REVIEW OF REQUESTS FOR EXCLUSION FROM PROBATIONARY REPORTING AND FEES, TULE SUBBASIN

March 2026

Figure 3. Percent of allowable subsidence through 2040 reached at land subsidence Representative Monitoring Sites as of July 2025.

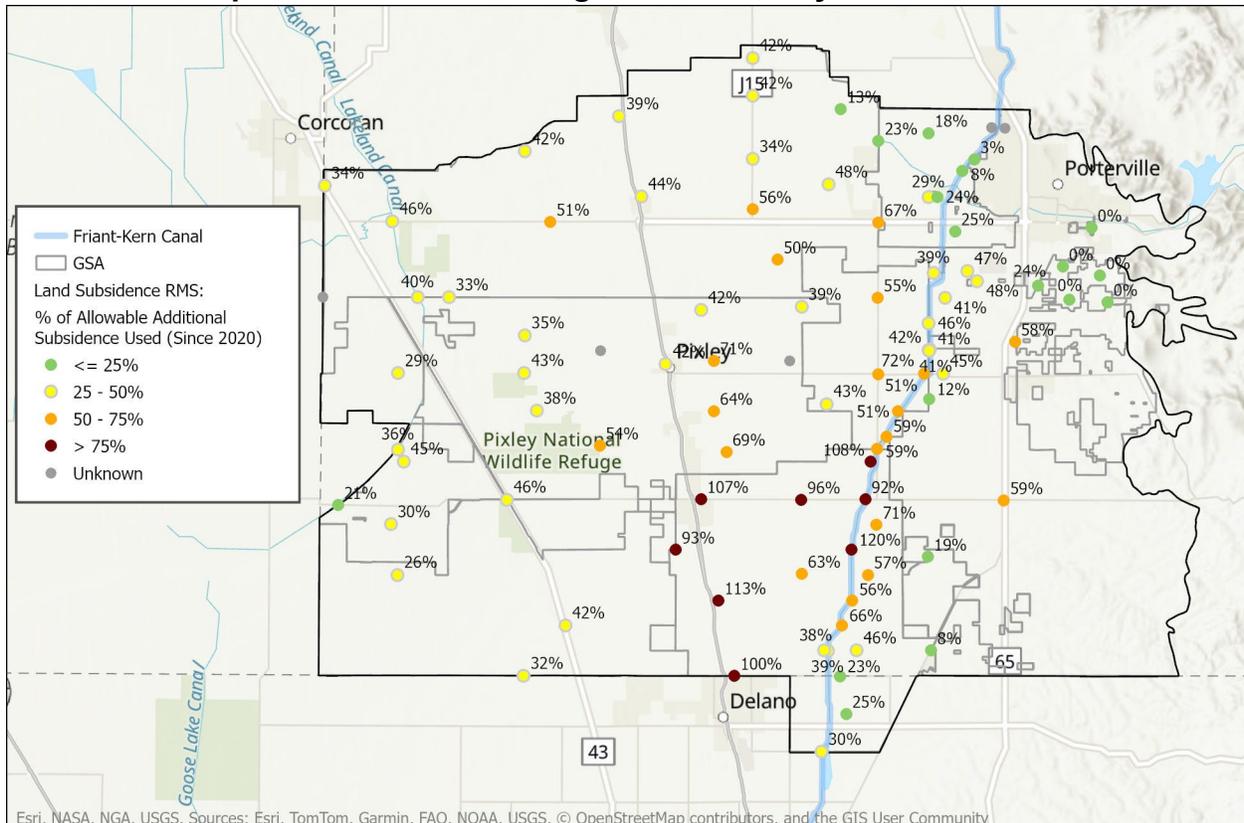
than in western GSAs, six of eight Saucelito RMS have reached or exceeded 50% of the subsidence allowable in the 2024 GSP, highlighting growing concerns about subsidence trends and management in eastern GSAs. GSAs' current management approaches do not appear to be sufficient to stop subsidence at the 2040 target and, if following the same trajectory, will more than likely exceed their 2040 targets, potentially as soon as 2028 in some areas (EKI, 2025).

Figure 4. Comparison of lower aquifer interpolated minimum thresholds and estimated critical head at nine sites in the subbasin (from Intera Inc., 2025).

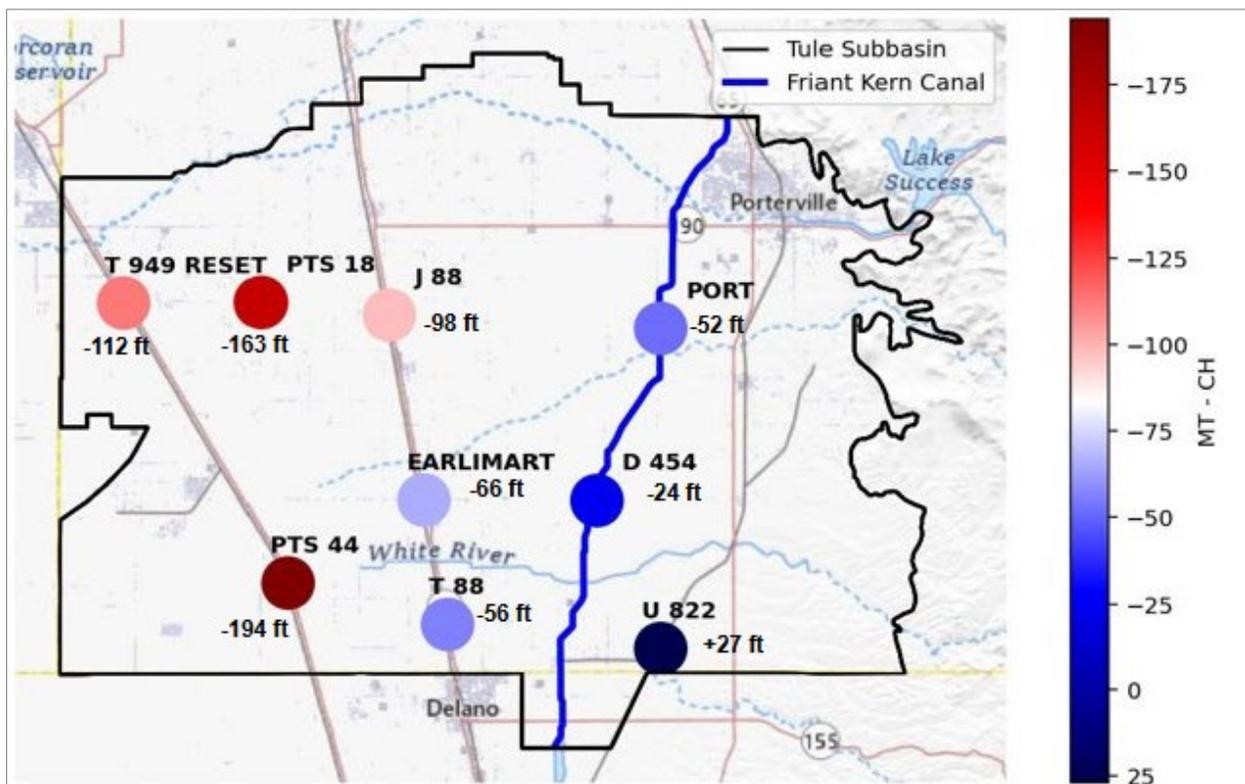
estimate lower aquifer critical head at 10 sites in the Tule Subbasin (California Department of Water Resources, 2025b). However, the 10 sites are not the same as the GSAs' RMS with water level MTs. Intera Inc. (2025) estimated the water level MTs at 9 of these 10 locations by interpolating from RMS and comparing these values to DWR's estimated critical head (Intera Inc., 2025). Results indicate that lower aquifer water level MTs in the subbasin would need to be raised by 24 to 194 feet (Figure 4) to reach critical head at 8 of the 9 sites, though there is uncertainty inherent in both the interpolation methods and the critical head evaluations. Of the 9 sites, only 1 in the southeast Tule Subbasin (U 822) currently has interpolated water level MTs above the estimated critical head, meaning that most lower aquifer water level MTs in the subbasin may need to be raised significantly to slow subsidence impacts.

Figure 5. Comparison of average 2024 lower aquifer groundwater levels (averaging spring and fall water levels) with estimated critical head values (from Intera Inc., 2025).

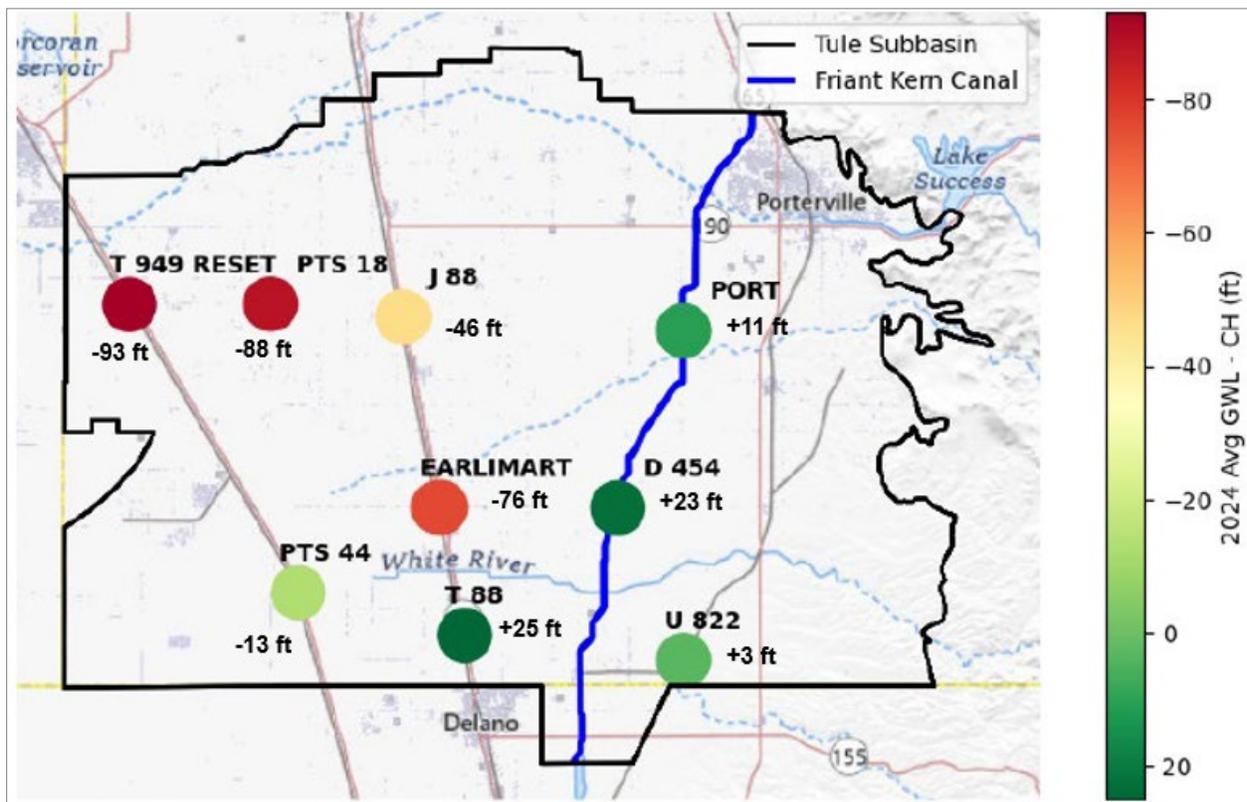
In addition to water level MTs being set at levels that, if followed, would result in continued subsidence, current water levels in the lower aquifer are maintained too low to slow or stop subsidence impacts. Comparing the average 2024 lower aquifer groundwater levels at the sites with estimated critical head indicates that the 2024 average groundwater levels (averaging spring and fall levels together) at five of the nine sites are 13 to 93 feet below estimated critical head (Figure 5) (Intera Inc., 2025). Four sites in the subbasin have groundwater levels above the estimated critical head, while

the site in Lower Tule, located near the intersection of Lower Tule, Pixley, and Tri-County GSAs, has the water level the furthest below estimated critical head (93 feet). This comparison is for average water levels, which means that fall water levels may actually be far lower than the annual average water levels, and spring levels much higher. DWR (2025) states that at least monthly water level measurements are essential for managing subsidence in order to capture seasonal lows when inelastic compaction may occur (California Department of Water Resources, 2025b). Where average water levels appear above critical head in Figure 5 (positive values), it is possible that seasonal lows could still result in inelastic compaction.

Figure 6. Comparison of average 2024 Santa Margarita and Pliocene groundwater level with estimated critical head values (from Intera Inc., 2025).

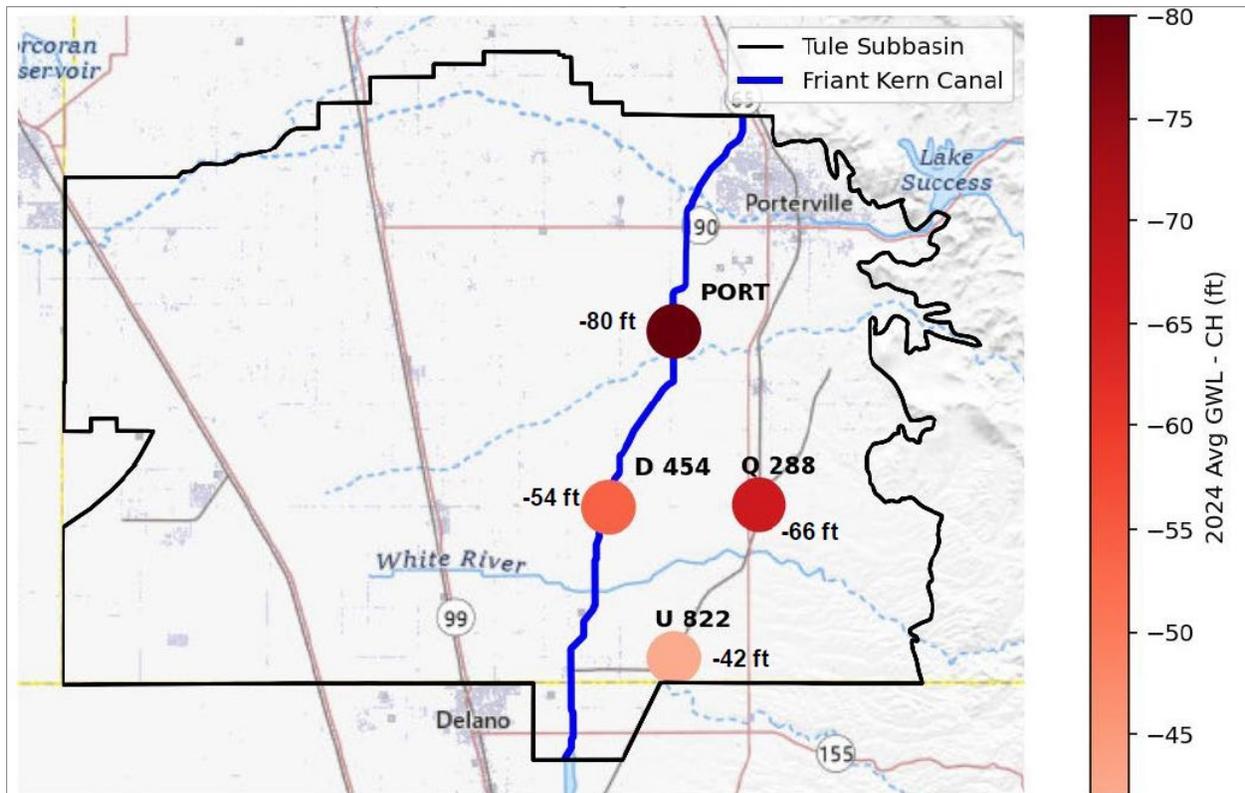
Where subsidence risks are greatest for infrastructure, there is a lack of monitoring or sustainable management criteria in the Santa Margarita and Pliocene aquifers, and water levels are too low to slow or stop subsidence. Although the Santa Margarita aquifer and Pliocene deposits are considered active risk zones for additional inelastic subsidence in the Tule Subbasin (Intera Inc., 2025), only two RMS in the Kern-Tulare GSA currently monitor groundwater levels in these units (2024 Tule Subbasin GSP Coordination Agreement, Attachment 1). Comparison of average 2024 groundwater levels to the estimated critical head at four sites (Figure 6) indicates that 2024 average

groundwater levels (averaging spring and fall water levels) are 42 to 80 feet below the critical head (Intera Inc., 2025). Because of the elevated risk and limited monitoring coverage, additional groundwater level monitoring locations and more frequent monitoring of these aquifers are needed to adequately evaluate subsidence risks and impacts.

Figure 8. Key Portions of the Individual Mitigation Structures, the Draft Subbasin Mitigation Plan, and Areas Needing Revision.

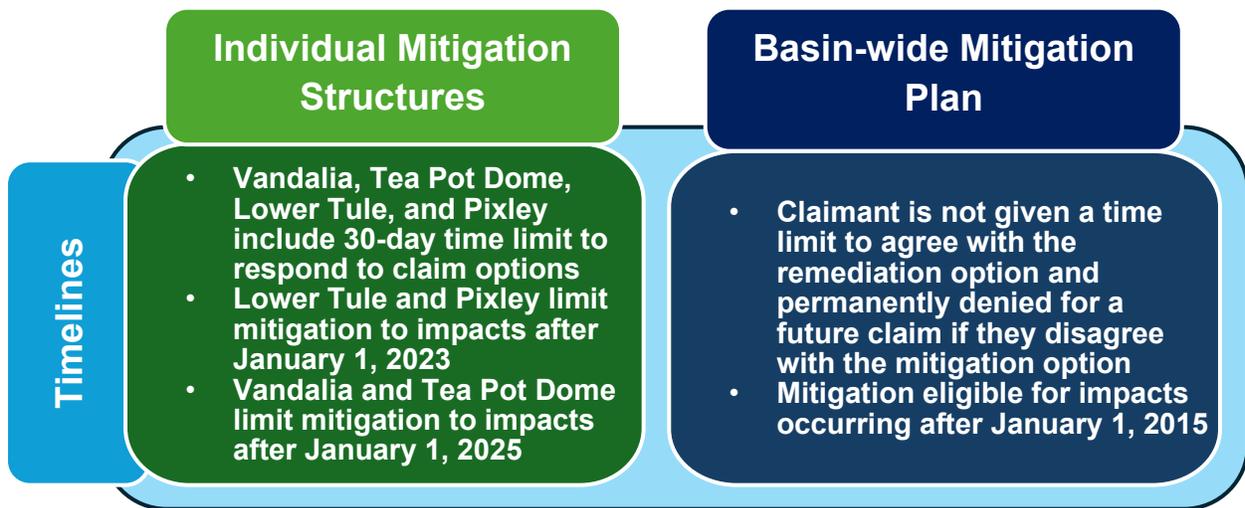
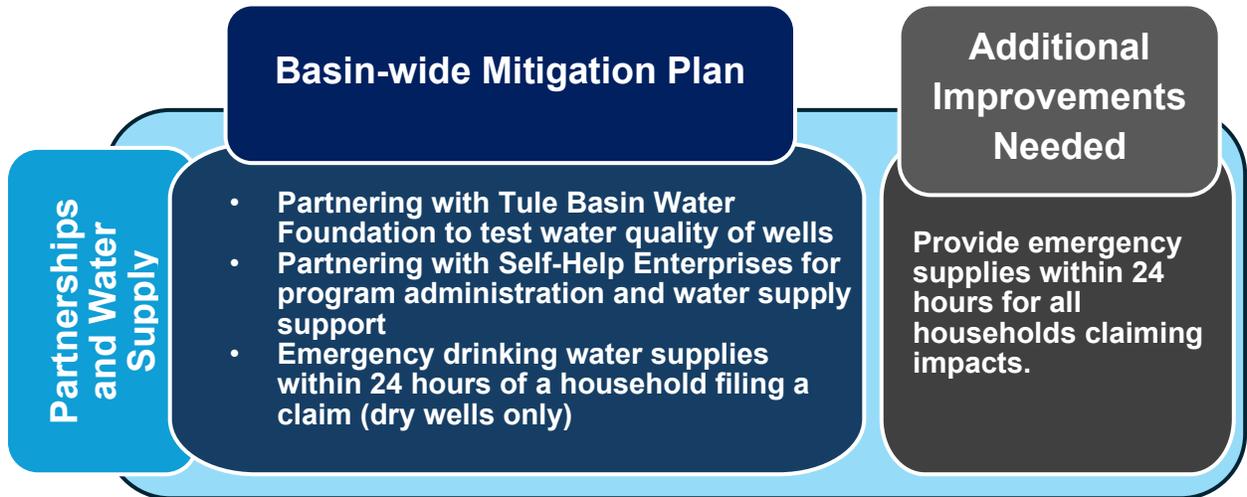
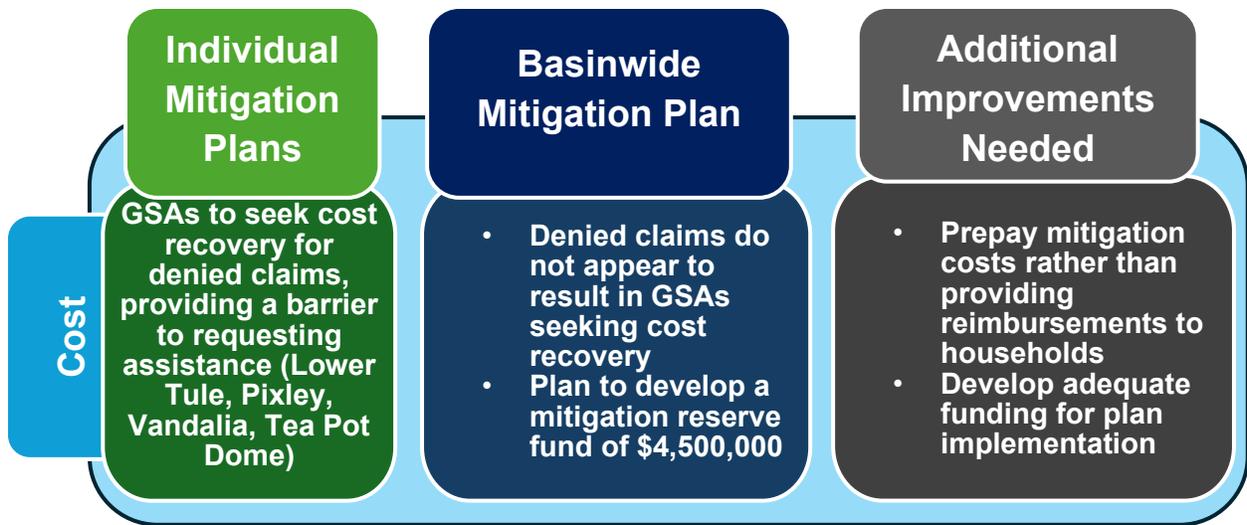
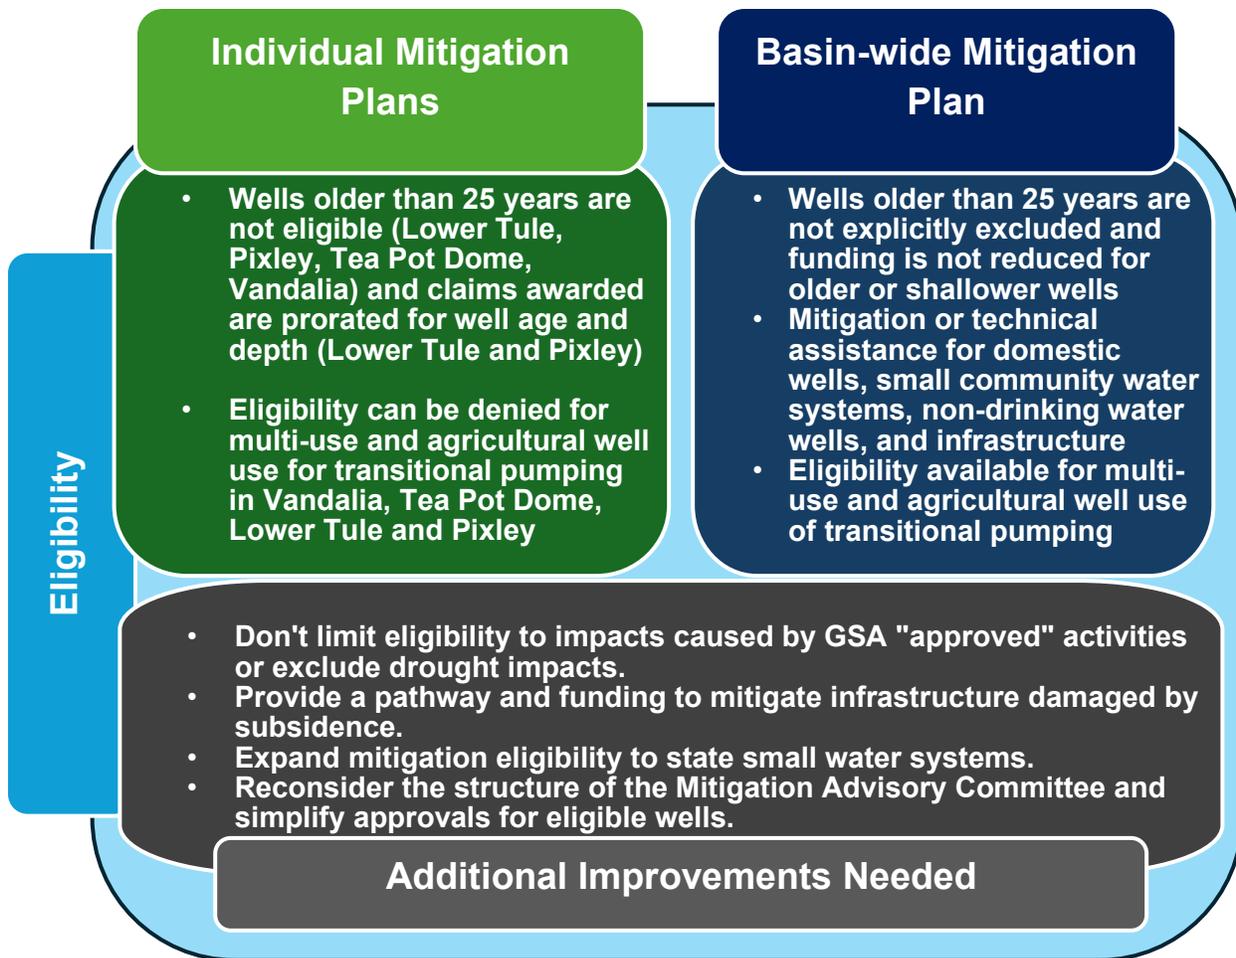
Water Board staff is encouraged by the progress reflected in the Draft Tule Subbasin Mitigation Plan. However, improvements are still needed in the Draft Tule Subbasin Mitigation Plan. While not exhaustive, Figure 8 portrays some key issues of concern in individual mitigation structures, improvements made in the draft Tule Subbasin Mitigation Plan and highlights some areas of improvement the GSAs should consider in future revisions of the draft Tule Subbasin Mitigation Plan. As a coordinated and consistent approach is preferable over the current approach of individual programs, the GSAs should focus on making revisions that address the improvements needed in the draft Tule Subbasin Mitigation Plan, rather than the individual programs.
